Essex County Council  
County Hall  
Market Square  
Chelmsford  
CM1 1QH

Mr Simon Pepper  
Senior Project Manager  
National Grid  
East Anglia Green

Our Ref: MW/EAG.NSR22  
Date: 16 June 2022

**RE: Town and Country Planning Act 2008. National Strategic Infrastructure Project East Anglia Green. Non Statutory Consultation Q2 2022.**

Map 1 – Minerals and Waste Safeguarding Screening – Full Extent of Proposed Development

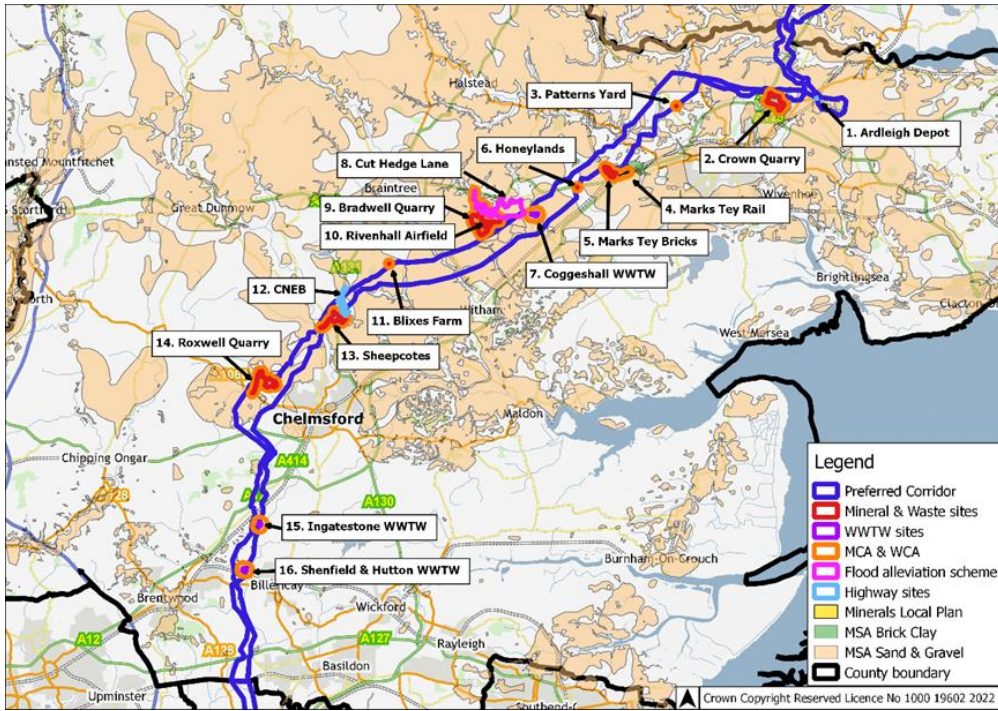
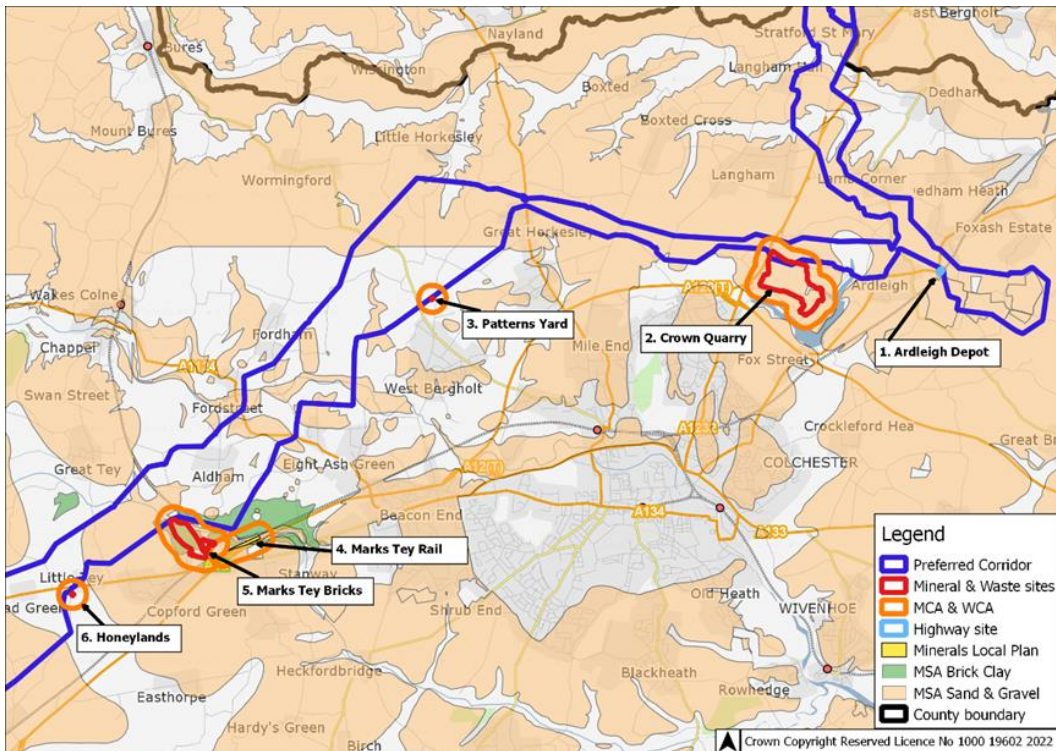
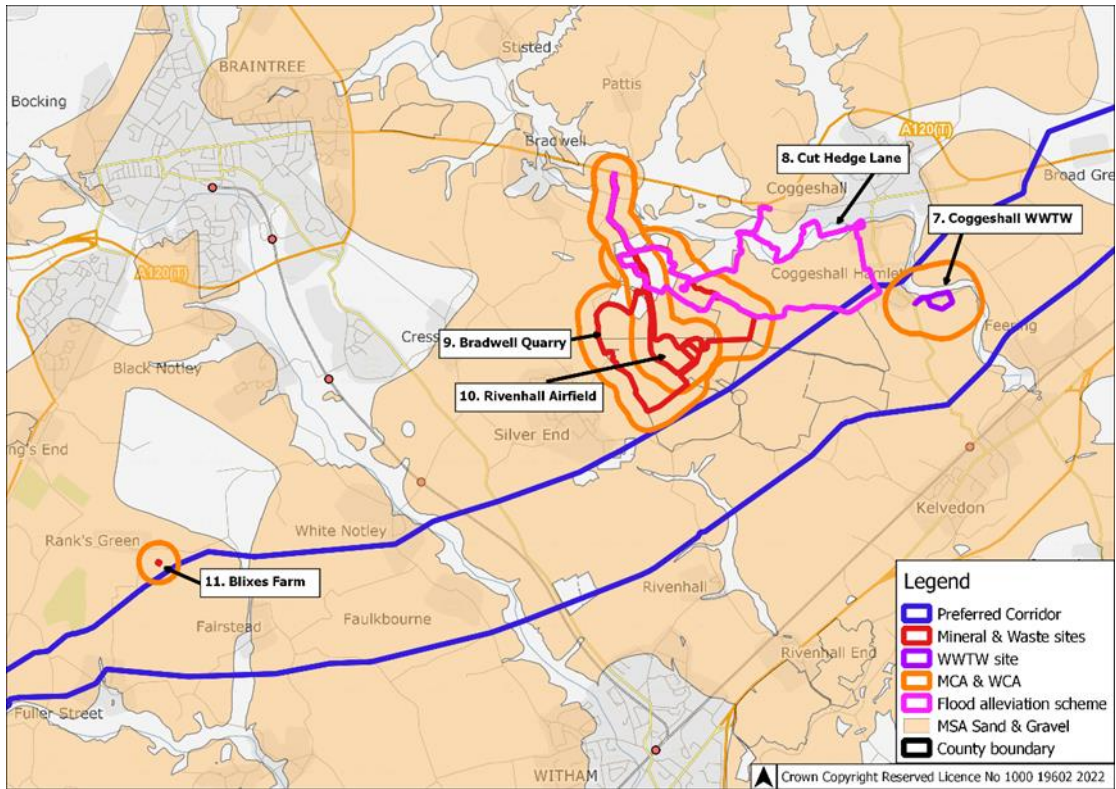
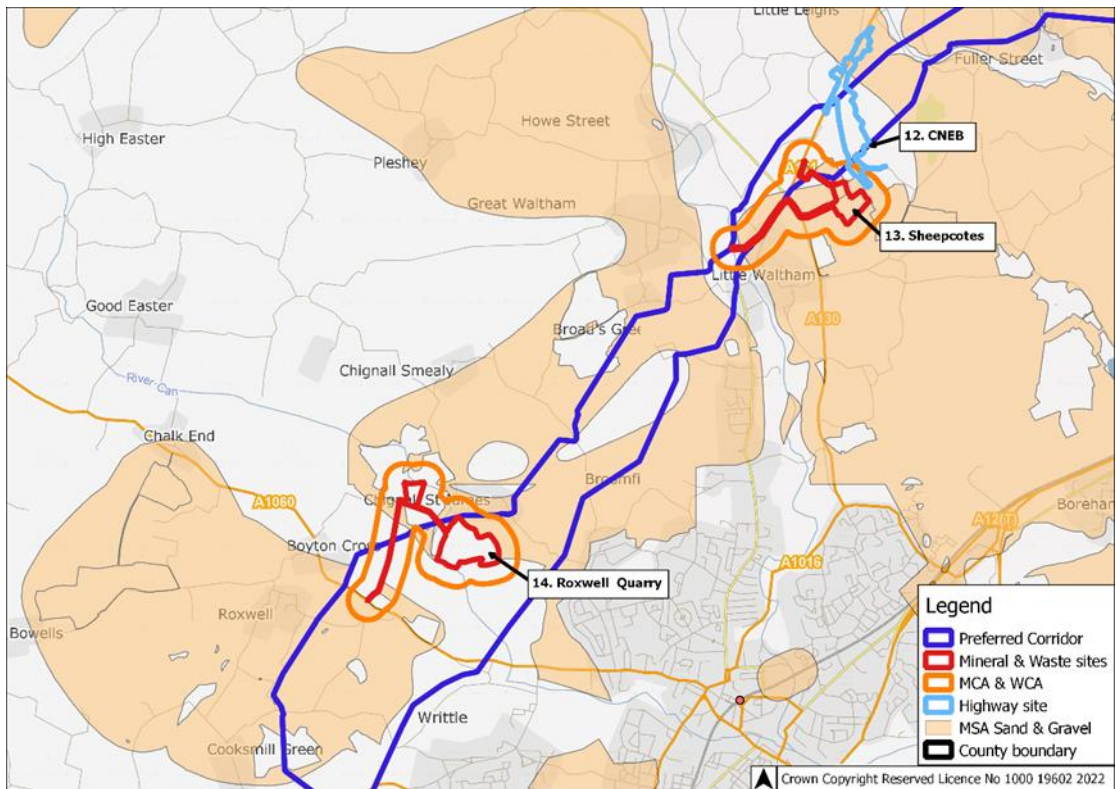
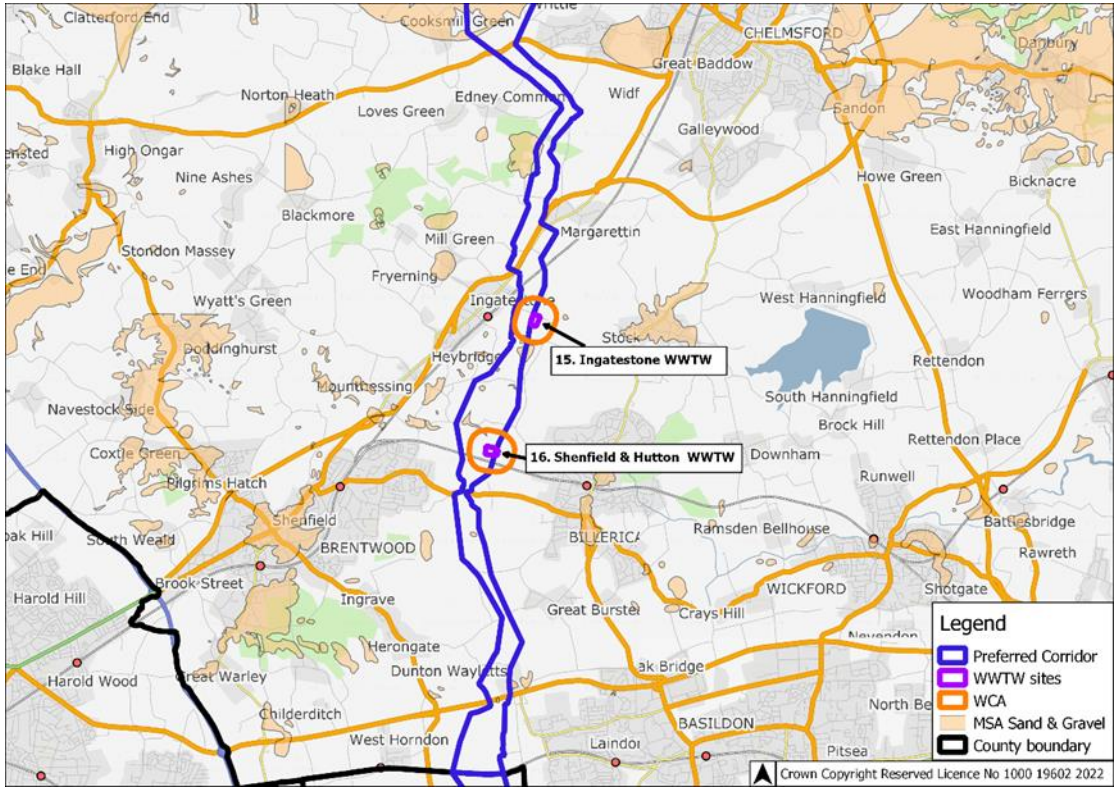
This response deals with mineral policy matters and waste policy matters in turn. A spatial representation of the application site and the matters discussed can be found in Appendix Two. A list of relevant designations and specific facilities which would potentially be affected are listed, with their most recent planning application reference where relevant, in Appendix Three. There then follows comments relating to the East Anglia Green Energy Enablement Corridor and Preliminary Routeing and Siting Study Report, 2022.

The application site passes through a number of Waste Consultation Areas as shown in Appendix Two. Its location within these Waste Consultation Areas means that an application would be subject to Policy 2 of the Essex and Southend-on-Sea Waste Local Plan 2017 (WLP). The WLP can be viewed on the County Council's website via the following link:
